**TECHNICAL BULLETIN**

**212-15-214**

**SUBJECT:** TAIL ROTOR GEARBOX INPUT QUILL LEAK, PREVENTION OF

**Figure 1**

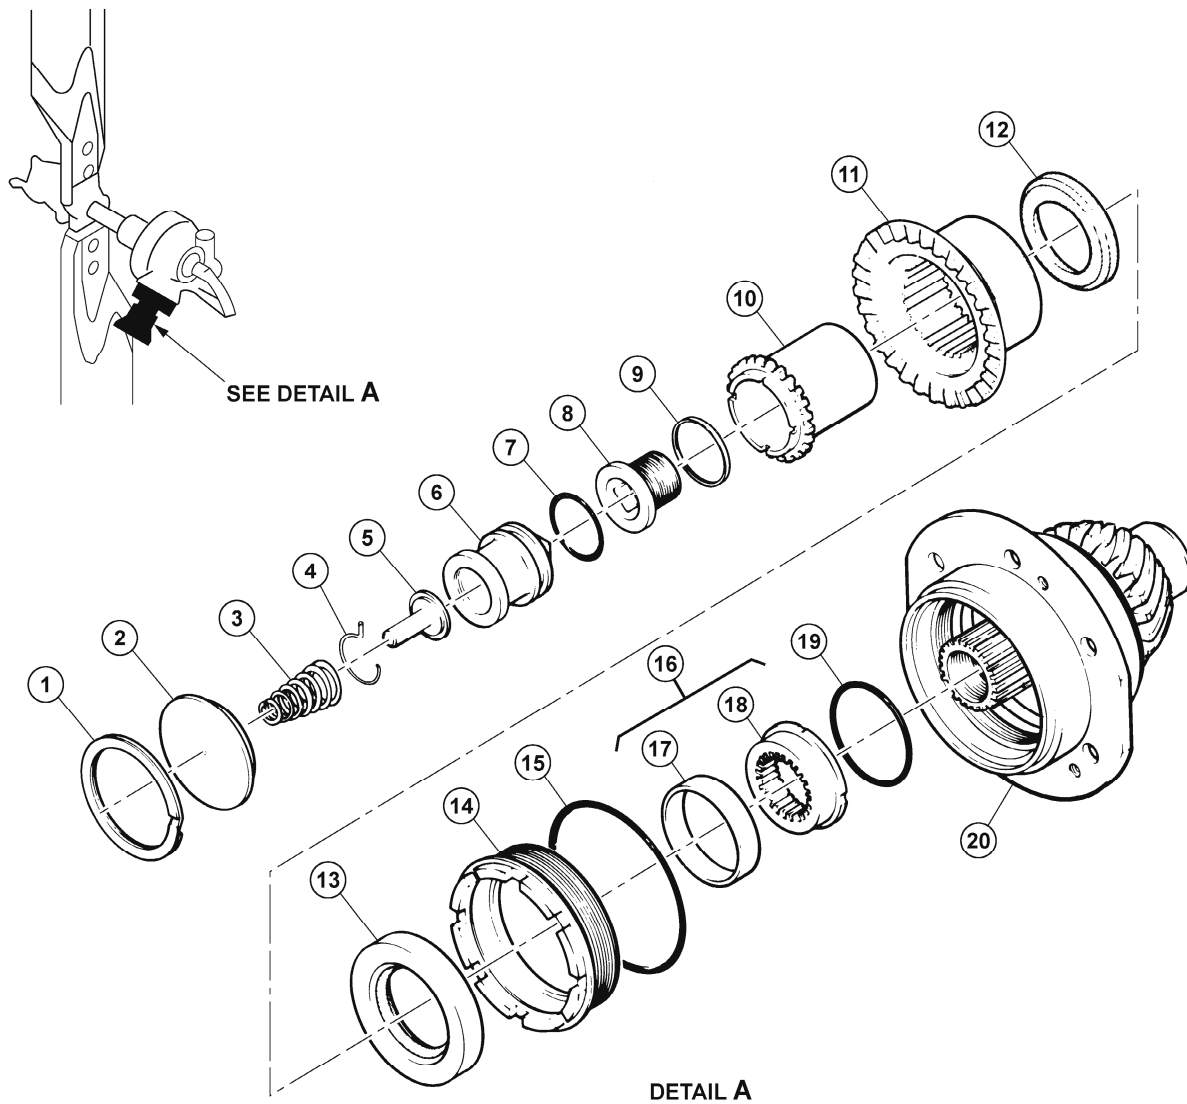
There have been some reported cases of oil leakage from the tail rotor gearbox input quill not caused by the seal. These occurrences have been noticed on both new production gearboxes and those with some time in service. The introduction of a revised spacer, along with the addition of a packing, will prevent the oil leakage between the spacer and the bearing. Applicability of this bulletin to any spare part shall be determined prior to its installation on an affected helicopter.

This bulletin provides the instructions to install the new spacer assembly 212-040-457-101 to prevent the oil leak between the spacer and the bearing.

1. Disassemble the tail rotor gearbox input quill to the extent necessary to remove the original spacer assembly (Figure 1, Item 16) in accordance with the BHT-212-CR&O, Chapter 65.
2. Install packing P/N AS3209-217 (Figure 1, Item 19) on the pinion assembly followed by the new spacer assembly 212-040-457-101.
3. Assemble the tail rotor gearbox input quill in accordance with the BHT-212-CR&O, Chapter 65.
4. Make an entry in the helicopter logbook and historical service records indicating compliance with this Technical Bulletin.
